7.7 Control Systems Not Required for Safety

The information in this section of the reference ABWR DCD, including all subsections and figures, [as modified by the STP Nuclear Operating Company Application to Amend the Design Certification rule for the U.S. Advanced Boiling Water Reactor \(ABWR\), "ABWR STP Aircraft Impact Assessment \(AIA\) Amendment Revision 3," dated September 23, 2010](#) is incorporated by reference with the following departures and supplements.

Figure 7.7-11 Simplified Functional Diagram of the Automatic Power Regulation System

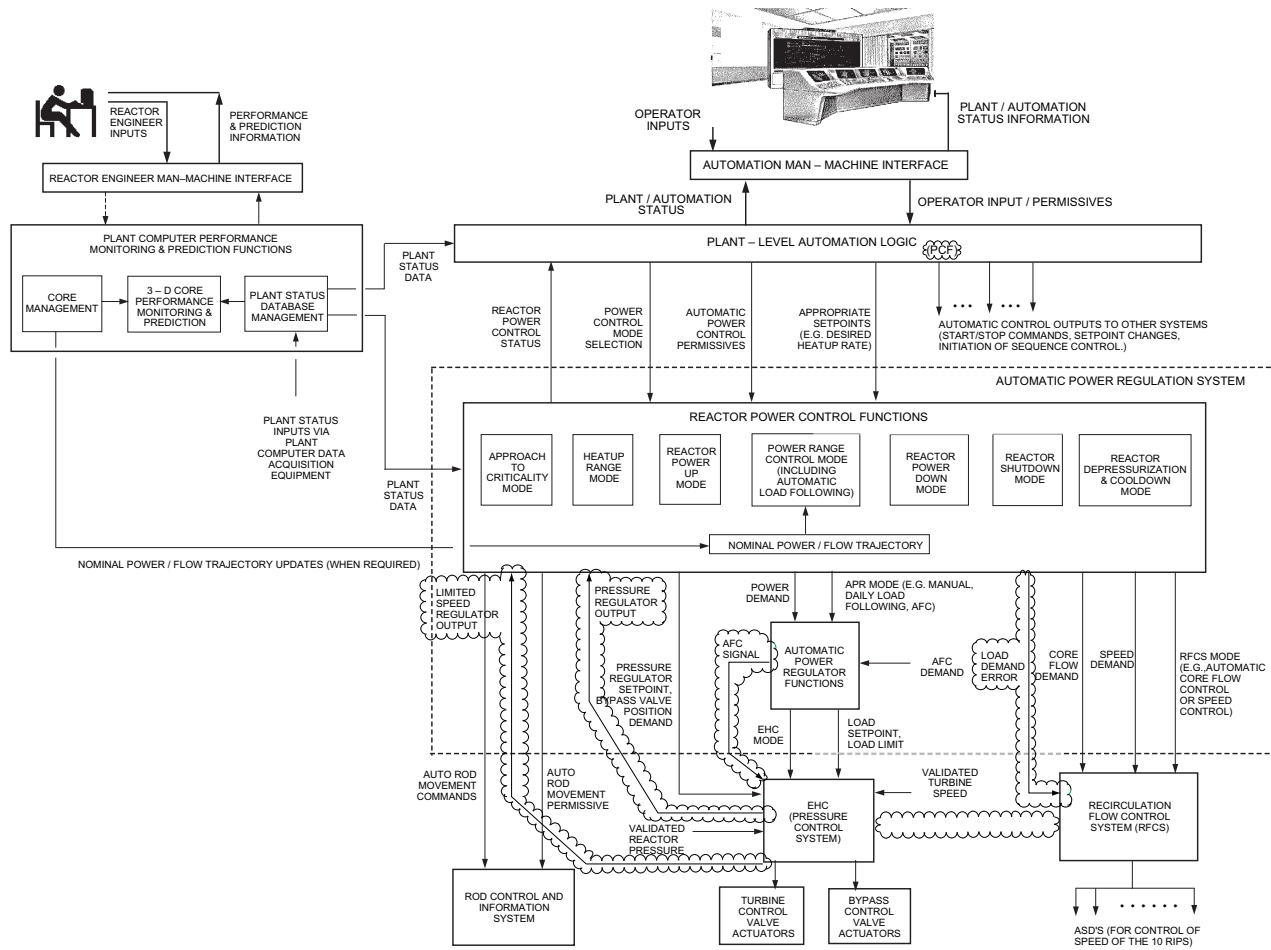
STD DEP 7.7-20 (Figures 7.7-5, 7.7-7, 7.7-11)

STD DEP 7.7-24 (Figures 7.7-11, 7.7-12, 7.7-13)
